**METROPOLITAN GOVERNMENT OF NASHVILLE AND DAVIDSON COUNTY**

**STAFF RECOMMENDATION**  
**1518 Sweetbriar Avenue**  
**July 18, 2012**

**Application:** New construction – addition  
**District:** Belmont-Hillsboro Neighborhood Conservation Zoning Overlay  
**Council District:** 18  
**Map and Parcel Number:** 11704003600  
**Applicant:** Mike Briggs, Contractor  
**Project Lead:** Melissa Baldock, melissa.baldock@nashville.gov

<p><b>Description of Project:</b> The applicant is proposing to construct a new side dormer on the right side of the house.</p> <p><b>Recommendation Summary:</b> Staff recommends approval of the application to construct a new dormer with the conditions that staff review the location of the dormer once the roof opening has been cut and staff review and approve the dormer windows prior to purchase and installation.</p> <p>With these conditions, staff finds the dormer to meet Sections II.B.1. and II.B.2. of the <i>Belmont-Hillsboro Neighborhood Conservation Zoning Overlay: Handbook and Design Guidelines</i>.</p>	<p><b>Attachments</b> <b>A:</b> Elevations</p>
--	--

CARIA LEE		APPROVED BY:	
1518 SWEETBRIAR AVE.		DRAWN BY: M	
SCALE: 1/8" = 1/4"		DATE: 7/5/12	REVISED
DRAWING NUM

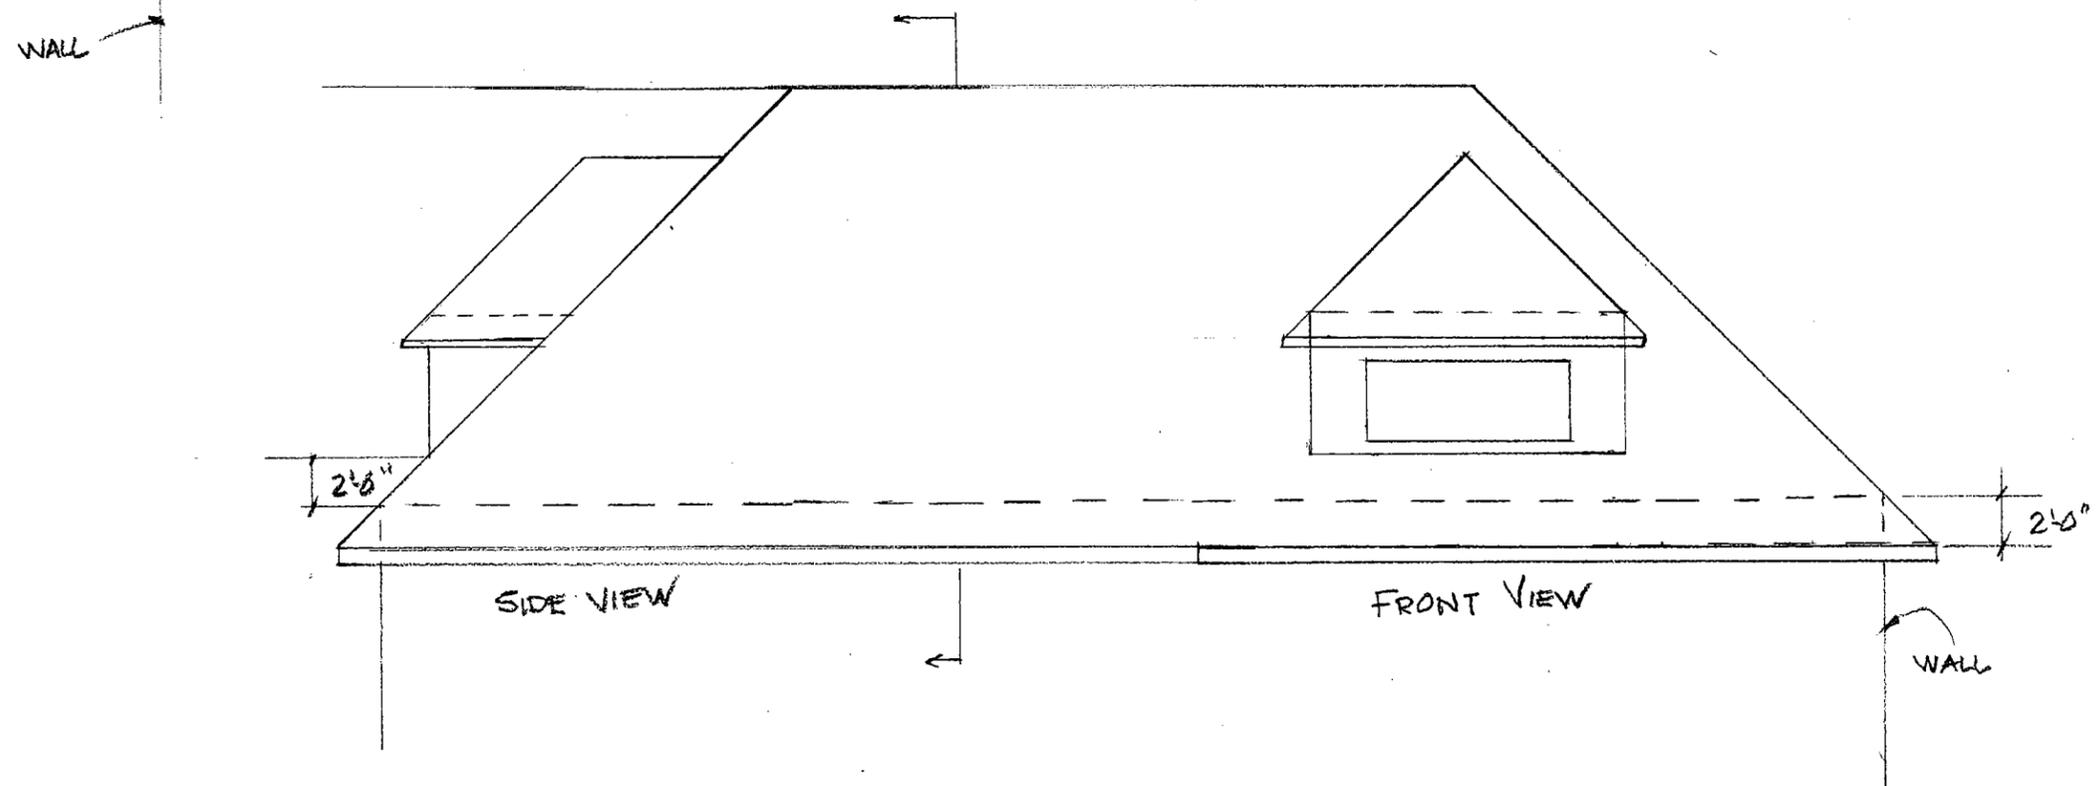
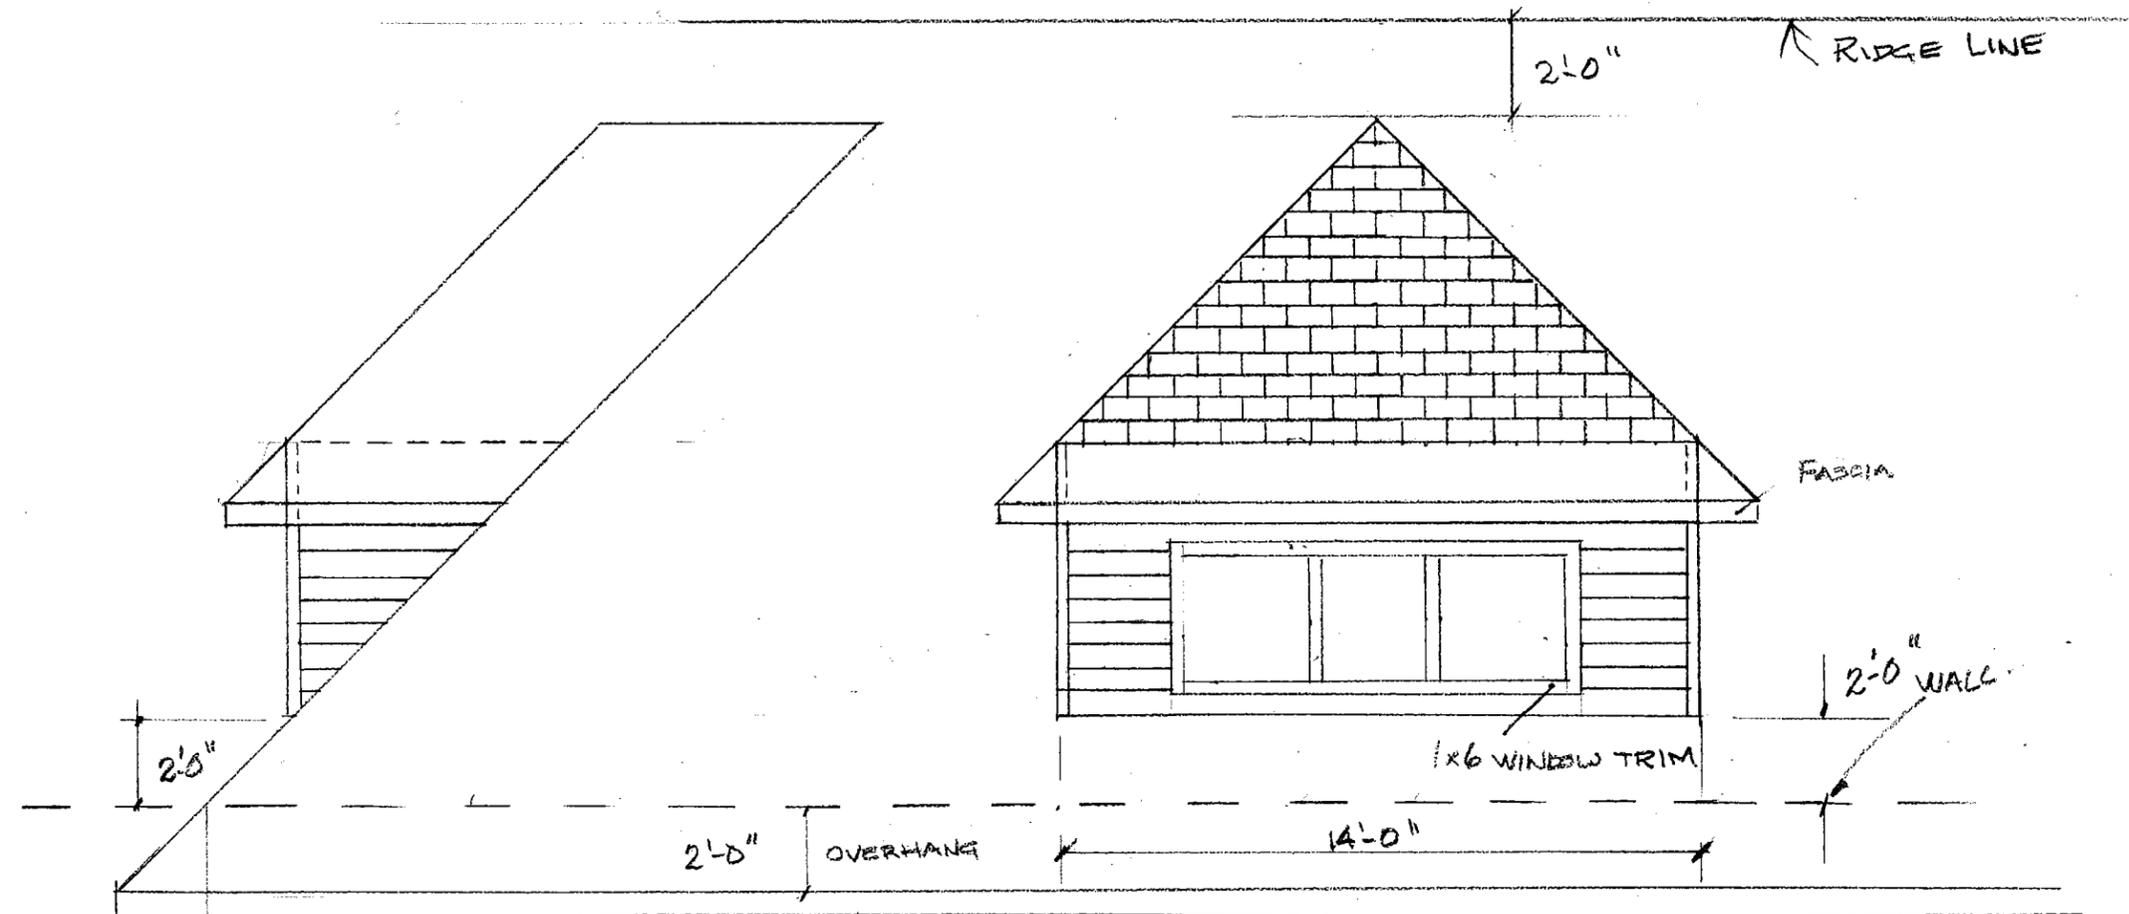
The proposed new dormer on the right side will also be located towards the rear of the house (see photo on next page), and will match the existing right side dormer in hipped roof form and height. It will have a 12/12 roof slope, matching the slope of the house's roof. However, it will be wider than the existing left side dormer; it will be fourteen feet (14') in width and will accommodate three windows. The new dormer will be inset two feet from the wall of the house below and more than two feet (2') from the back wall of

the house. The ridge of the dormer will be two feet (2') below the ridge of the house. The dormer will not sit near any roof ridges, chimneys or other significant roof features.

New side dormers should be compatible with the scale and design of the house and should generally match the design and dimensions of any historic dormer on the house. Although this dormer is approximately six feet (6') wider than the existing side dormer, staff finds its size to meet the design guidelines because it is situated so far back on the house's roof, that its extra width will not be easily perceived. As with all new dormers, staff will want to approve the location of the dormer once it has been cut into the roof and before construction begins.

The dormer will be clad in wood or cement fiberboard siding to match the siding on the historic house. The materials for the windows were not specified and staff asks to review and approve the window material and specification prior to purchase and installation. The dormer's roof will be asphalt shingle to match the existing roof.

Staff recommends approval of the application to construct a new dormer with the conditions that staff review the location of the dormer once the roof opening has been cut and staff review and approve the dormer windows prior to purchase and installation.
